Attention:	Brian Richardson	Date:	1/12/2015
Company:	C.C.S. Constructors	Job Name:	Stowe BRF 0235(11)
Address:	138 Munson Ave	Job Number:	#15163
City, St, Zip:	Morrisville, VT 05661	Regarding:	Abutment, Wing Wall, and Retaining Wall Submittal #2
Ph: / Fax:	802-888-7701

Precast Bridge Abutments

Stowe BRF 0235(II)

PRECAST CONCRETE ABUTMENT SHOP DRAWINGS (SDI JOB #15163)

Wingwall 1 - 4: Typical Section

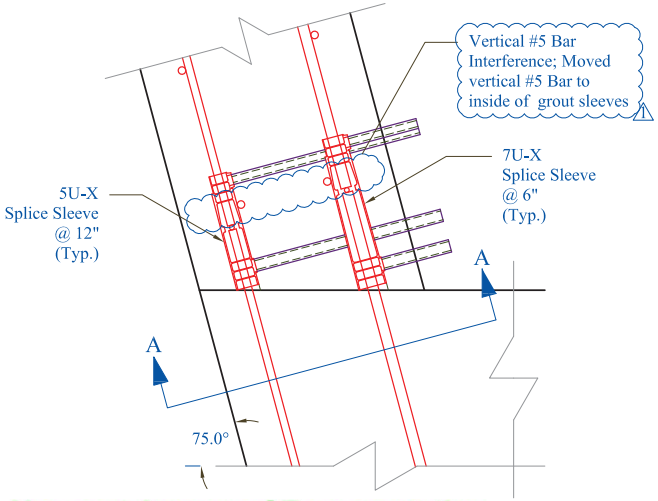
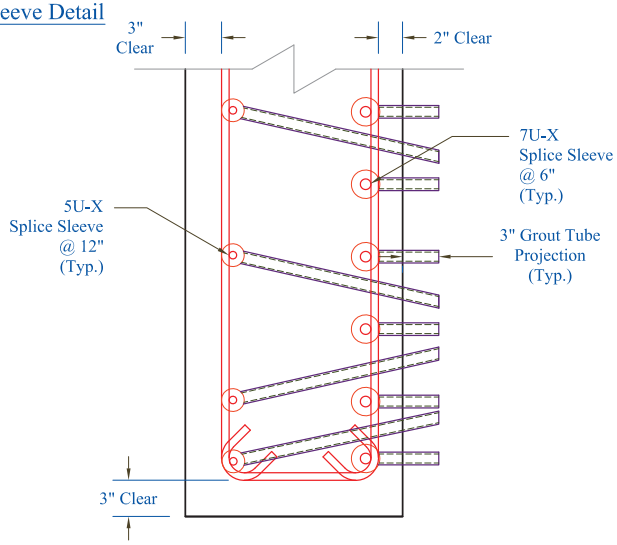
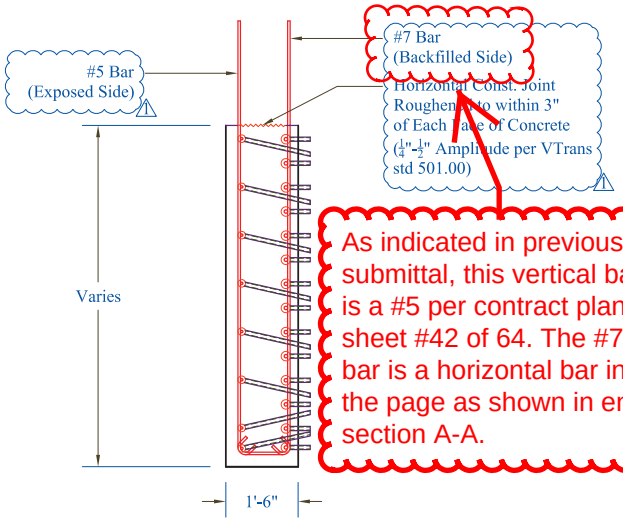
As indicated in previous submittal, this vertical bar is a #5 per contract plans sheet #42 of 64. The #7 bar is a horizontal bar into the page as shown in end section A-A.

Retaining Wall Typical Section

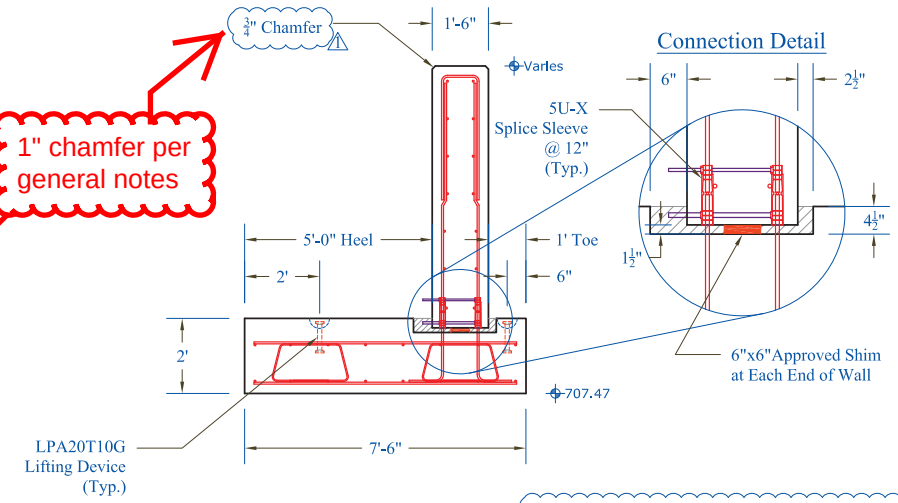
1" chamfer per general notes

See reinforcing sheet K for bar size/I.D.

ABUTMENT #1 PLAN
VERTICALS NOT SHOW FOR CLARITY

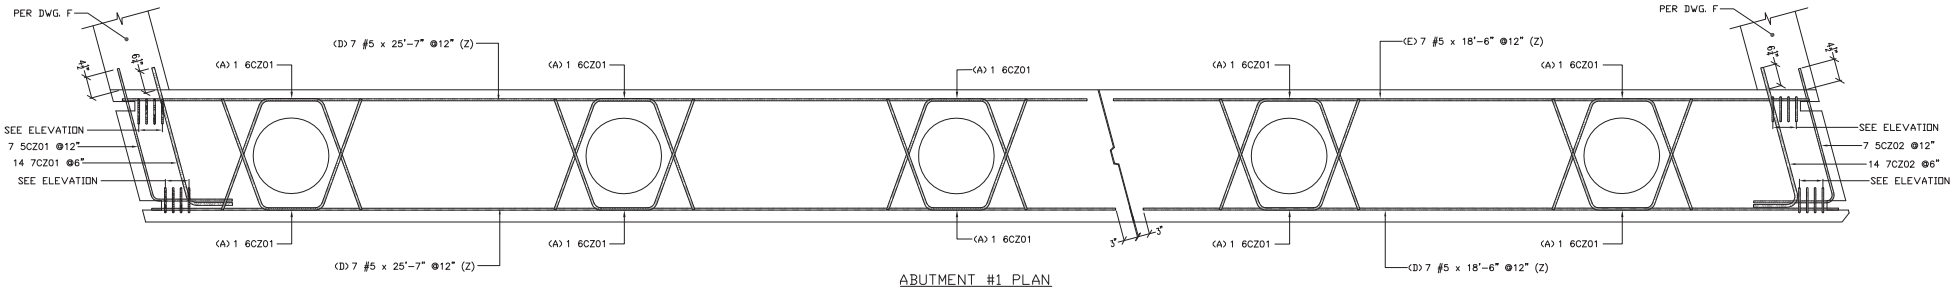
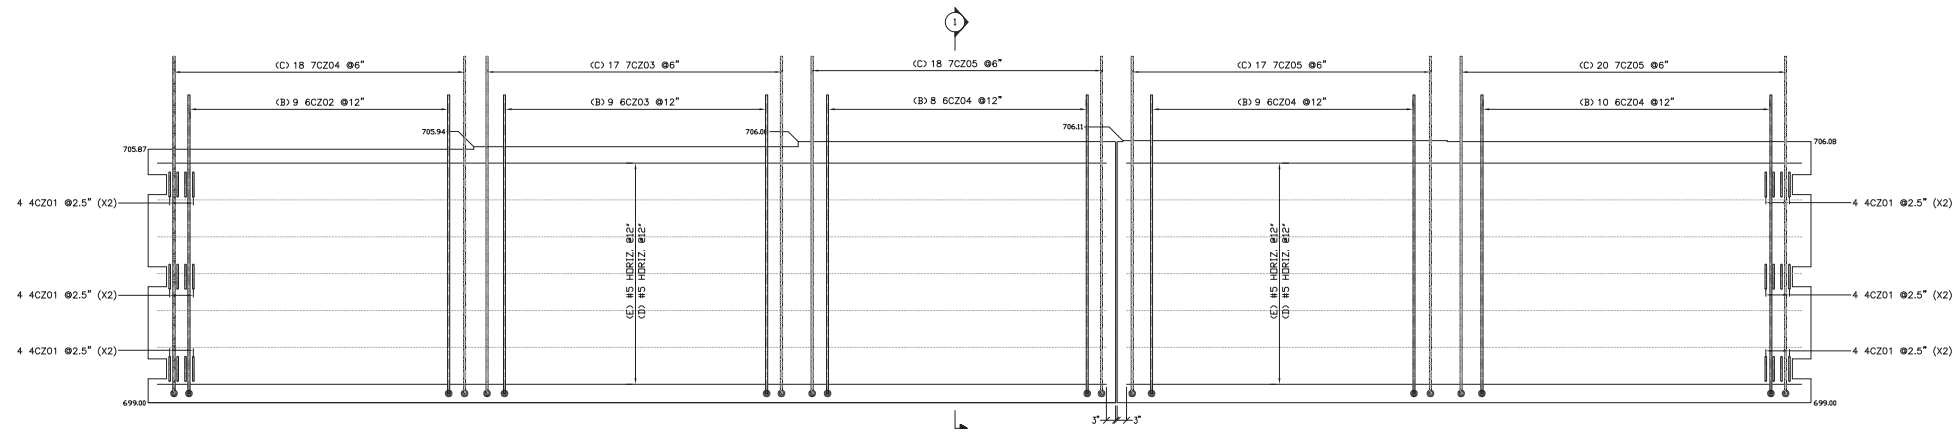
The vertical bars coming out of the abutments will either be spaced to avoid interference with the girders or cut where they interfere.

ABUTMENT #2 PLAN
VERTICALS NOT SHOW FOR CLARITY

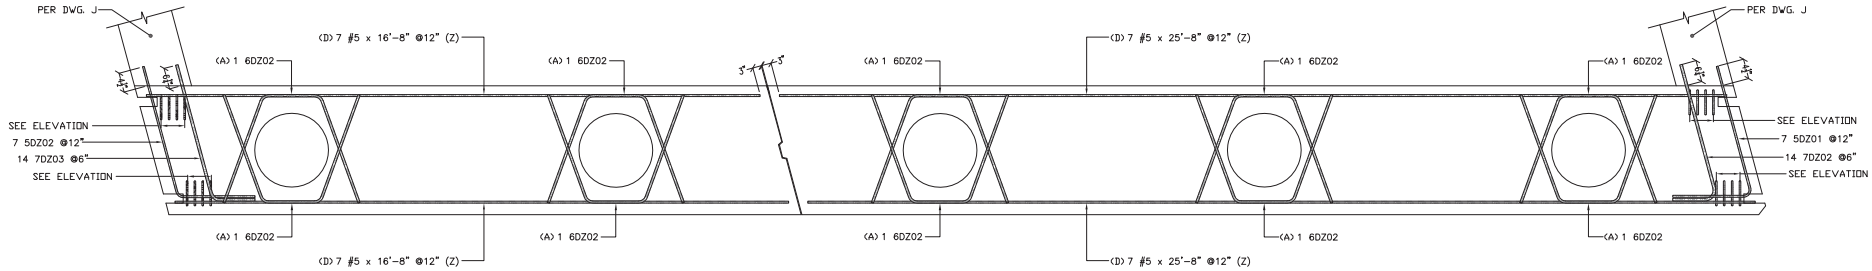
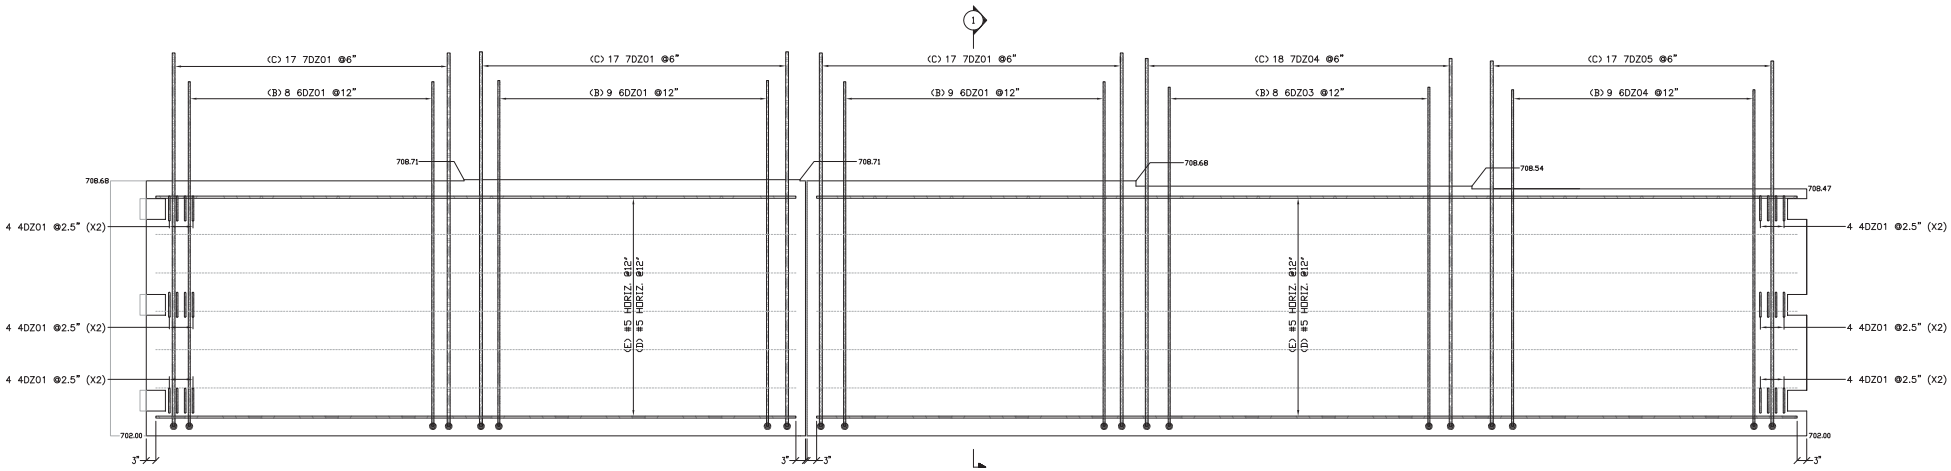
The vertical bars coming out of the abutments will either be spaced to avoid interference with the girders or cut where they interfere.
